SUNDRY NOTICES AND REPORTS ON WELLS
Do not use this form for proposals to drill or to re-enter an abandoned well. Use Form 3160-3 (APD) for such proposals.

8. Well Name and No. JICARILLA C/24

PLUG AND ABANDONMENT PROCEDURE

CONDITIONS OF APPROVAL

PROPOSED P&A WELLBORE DIAGRAM

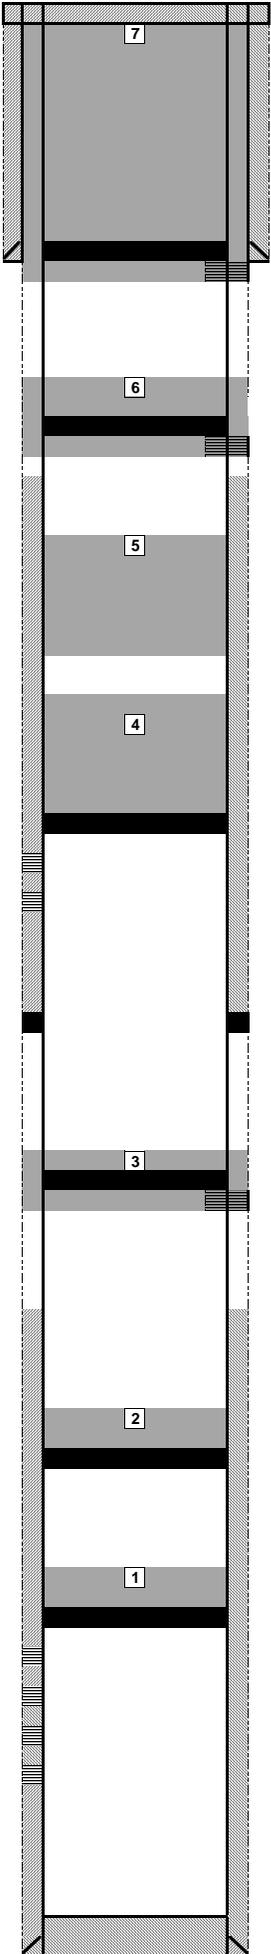
- BLM picks for the Nacimiento, Cliff House, and Mancos formation tops vary from operator.
- Adjust Plug #2 (Mancos) to cover BLM formation top pick at 5127'.
- Adjust Plug #3 (Cliff House) to cover BLM formation top pick at 4353'.
- Adjust Plug #6 (Nacimiento) to cover BLM formation top pick at 690'.
- The plugs proposed in the P&A procedure, with recommended changes, will adequately protect any freshwater sands in this well bore.
- Chacra perms 3622' – 3644'.
- Gallup perms 6111' – 6219'.

1. Plugging operations authorized are subject to the attached "General Requirements for Permanent Abandonment of Wells on Federal and Indian Lease."
2. The following modifications to your plugging program are to be made:
 - a) Adjust Plug #2 (Mancos) to cover BLM formation top pick at 5127'.
 - b) Adjust Plug #3 (Cliff House) to cover BLM formation top pick at 4353'.
 - c) Adjust Plug #6 (Nacimiento) to cover BLM formation top pick at 690'.
3. Farmington Office is to be notified at least 24 hours before the plugging operations commence at (505) 564-7750.
